# Access Compliance Report Public Rights-of-Way (Curb Ramps)

Main Street: N/A Cross Street: ROSSMOOR\_CENTER\_WAY Location: NW

ADA ID: RPRK211208120923 Ramp Type: Type 1 - Perpendicular Initial Pass/Fail: Fail Overall Compliance: No Severity Score: 15

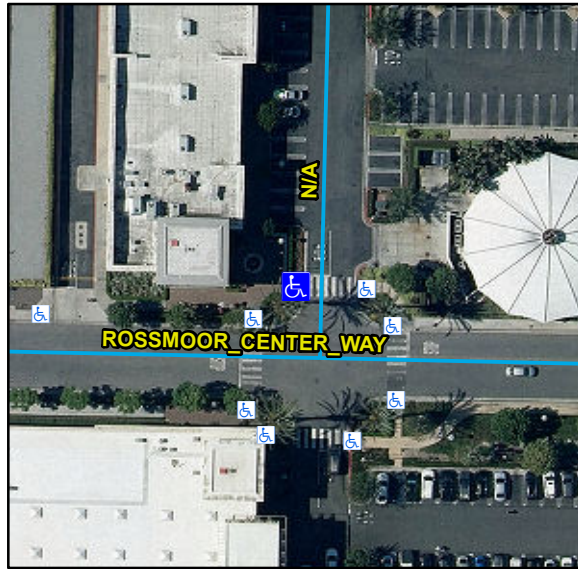
| Compliance | Description                                  | Data | Compliance | Description                   | Data |
|------------|----------------------------------------------|------|------------|-------------------------------|------|
| No         | Ramp Run Slope (%)                           | 9.8  | N/A        | Flare Slope LT (%)            | N/A  |

**Remove & Replace Entire Ramp.**

**R304.2.2, STD 1115**
